**Subject: CZ-19-0859-42 – Design Build Construction of Heating, Ventilation, and Air Conditioning (HVAC) at Multiple Sites – Package B (SDUSD Project # 9023007.1)**

## **Notice to Proceed: No. 07R4– HVAC Construction at Barnard Elementary School**

**Project:** SDUSD HVAC Design Build Projects **Construction NTP Adjustment No:** Barnard ES 008 R3

**Contract No:** CZ-19-0859-42 **Subject:** Ductless Split System - Removal from Scope

BLDG. 01-05 1 03-07 HVAC FLOOR PLAN  
 BARNARD ELEMENTARY  
 SCHOOL  
 HVAC 2000 PHASE 2  
 EDUCATIONAL SUPPORT SPACES  
 2445 FORB ST., SAN DIEGO, CA 92108

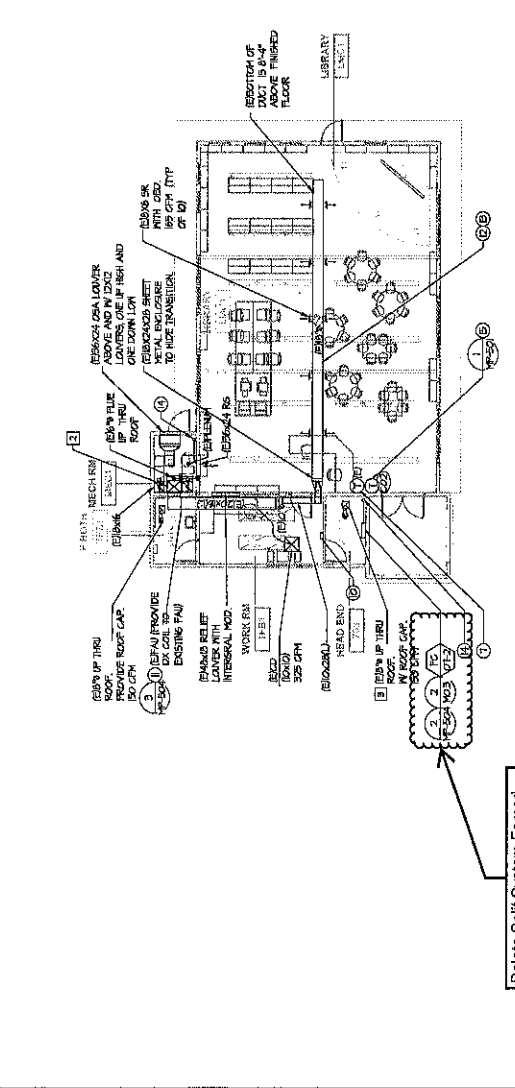
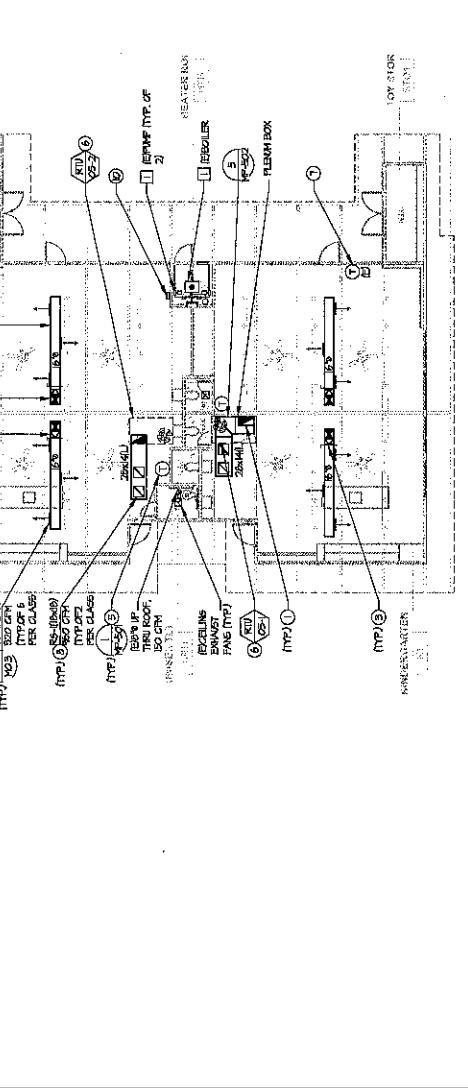
Delete Split System Forced Air Unit at Room 703
